Industry/TSTF Standard Technical Specification Change Traveler

Correct invalid SR for Containment Isolation Valve Position

STF-244

SR 3.3.3.2

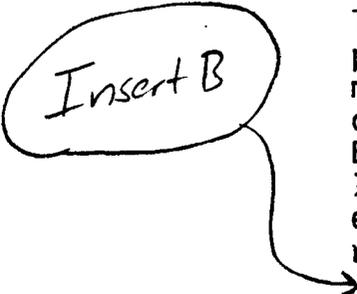
A CHANNEL CALIBRATION is performed every [18] months, or approximately at every refueling. CHANNEL CALIBRATION is a complete check of the instrument loop, including the sensor. The test verifies that the channel responds to measured parameter with the necessary range and accuracy. This SR is modified by a Note that excludes neutron detectors. The calibration method for neutron detectors is specified in the Bases of LCO 3.3.1, "Reactor Trip System (RTS) Instrumentation." The Frequency is based on operating experience and consistency with the typical industry refueling cycle.

Insert B

Insert BSR 3.3.3.3

SR 3.3.3.3 is the performance of a TADOT of containment isolation valve position indication. This TADOT is performed every [18] months. The test shall independently verify the OPERABILITY of containment isolation valve position indication against the actual position of the valves.
